Ofwat/RAPID Gate 1 assessment

This is our response to the Environmental part of the Abingdon Reservoir Gate 1 reports which were published on RAPID's web-site on 5th July 2021 and to Ofwat/RAPID's draft decisions on the Gate 1 proposals that were published in mid-September 2021.

Wantage and Grove Campaign Group

Figure 2-4 - 150Mm³ reservoir proposed scheme layout

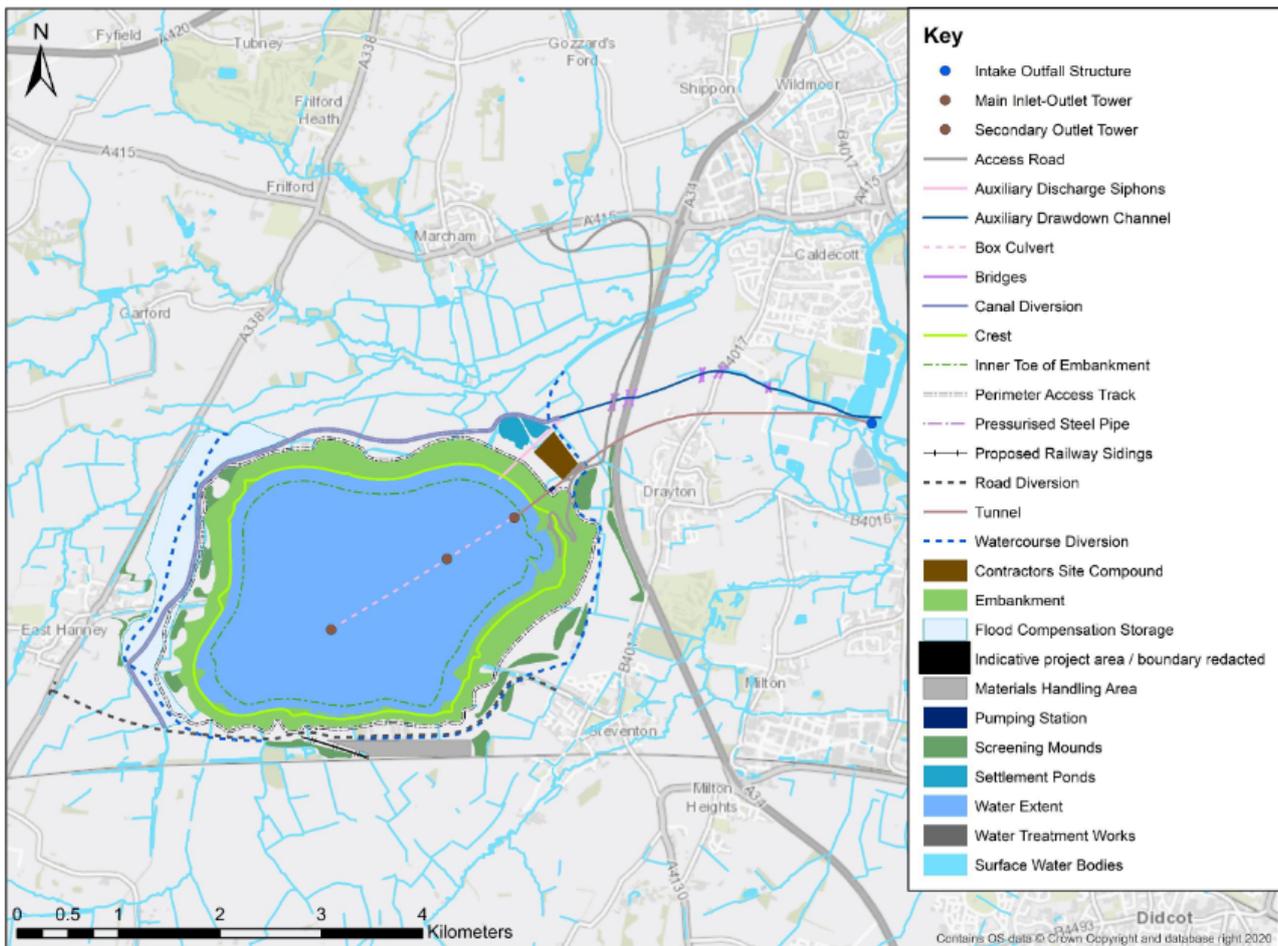
As can be seen from the maps included in the report (see example overleaf) there are villages very close to the reservoir on at least three sides (East Hanney, Drayton and

Steventon). No mention is made of the impact of the very high volume of housing development taking place in these villages (and in Marcham to the north) or the many thousands of new homes planned and being built in the rest of the OX12 area including Grove and Wantage (just south of the railway line which forms a boundary to the reservoir site).

The population of Steventon (south east of the site) has increased by approximately 1000 in the last 10 years. Marcham (to the north) and East Hanney, to the west, have both expanded by over 200 homes so far and plans are being formulated for a further 1000 homes just south of East Hanney.

The area that Thames Water identified 25 years ago as being suitable for a reservoir with a sparsely populated area, with only a couple of small villages to be affected has gone. In its place is an area crammed with some of the most intense levels of housebuilding in England. The eastern boundary is the A34, now one of the busiest roads in the UK and already at or over capacity.
